Evaluation and Findings Report Section 401 Water Quality Certification for the North Umpqua License Amendment (FERC Project Number 1927)

Submitted to: PacifiCorp

July 2022 (Updated November 2022)

Figure 4: Salmon and Steelhead Spawning Uses in the Umpqua Basin

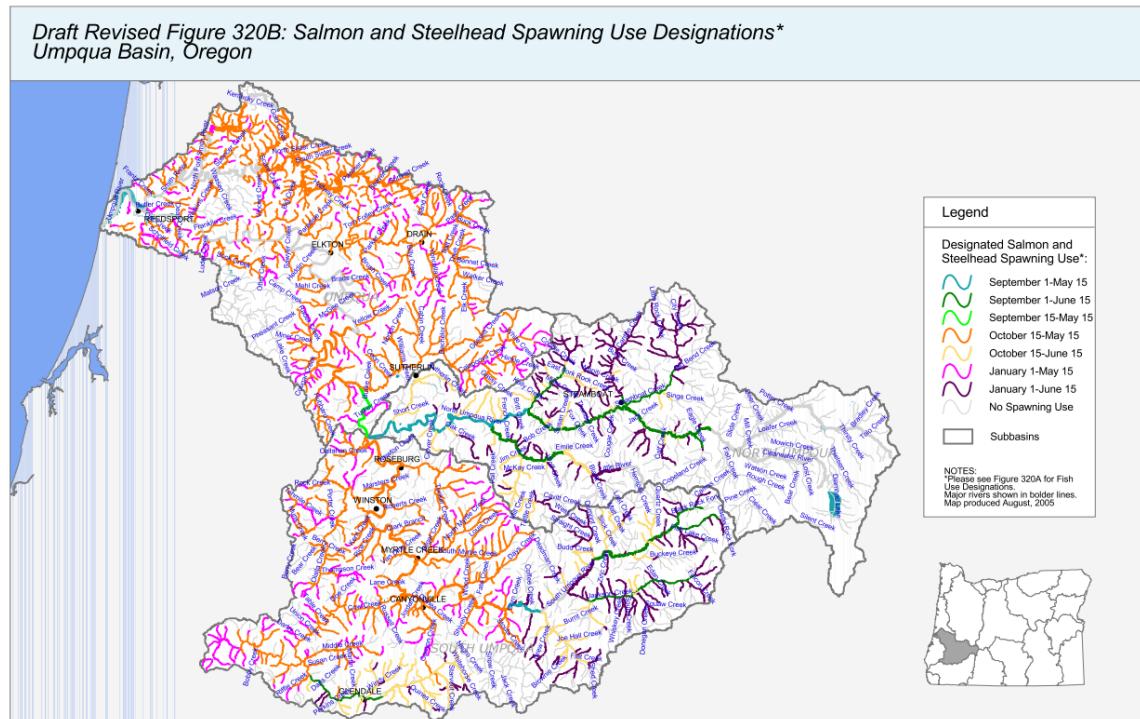
The last sentence of Draft Evaluation Report Section 4.1 (page 13) references "the salmon and steelhead spawning designations identified in Figure 2." This reference is incorrect. The salmon and steelhead spawning uses in the Umpqua Basin are presented in the Draft Evaluation Report figure inadvertently identified as Figure 41, which should be Figure 4, on page 14.
